MARK	DATE	DESCRIPTIONS	BY	CH'D	CCO#
0	03/08/10	MEP INTEGRATION	SYC	FW	110

DETAILS
BRIDGE STRUCTURES GIRDER EASTBOUND MAIN BRIDGE SYSTEM GROUNDING-EB
SCALE: 1:3000

E-839

SYSTEM GROUNDING PLAN

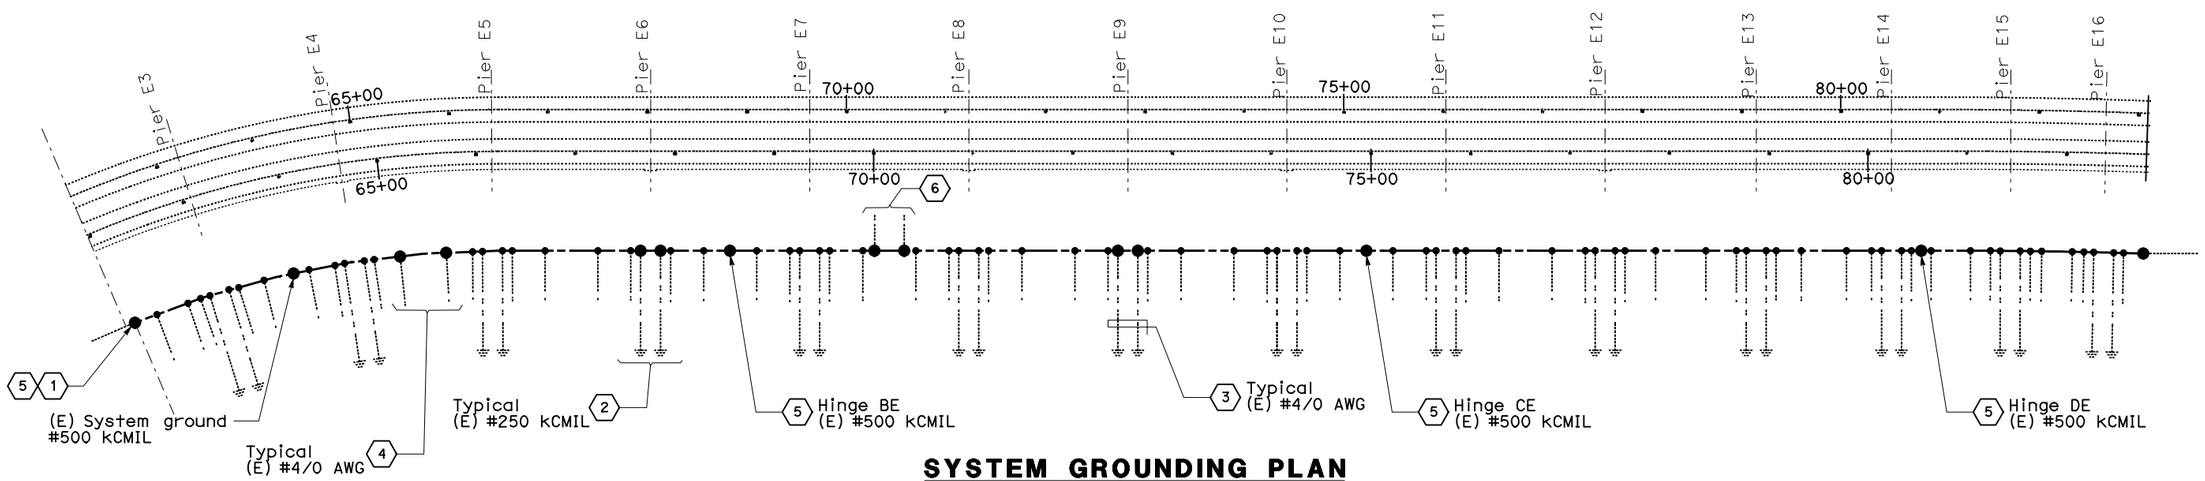
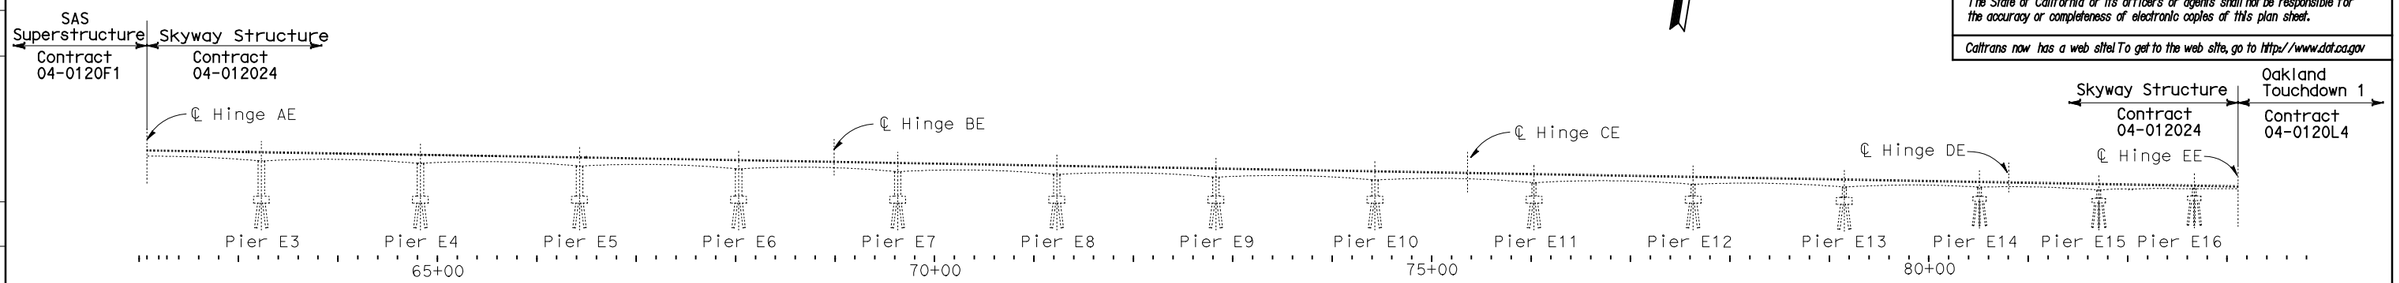
1. The Contractor shall connect the system ground provided by Skyway contract. The system ground #500 kCMIL shall be exothermically connected from SAS contract.

2. The Contractor shall visually inspect the ground connection to the pier column. The ground connection is #250 kCMIL to the system ground.
3. The Contractor shall visually inspect the ground connection to the service platform. The ground connection is #4/0 AWG, routed inside an existing conduit to the system ground.

4. The Contractor shall visually inspect the ground connection to the cable tray racks. The ground connection is #4/0 AWG, located 1/3 the distance between pier columns.

5. The Contractor shall disconnect and remove the connected system ground routed inside the existing hinge conduits. This ground conductor shall be re-installed together with 15 kV feeder cable. The ground conductors shall be exothermically connected.

6. The Contractor shall visually inspect the ground connections to the ground bar inside the substation. The bar is connected to the system ground.
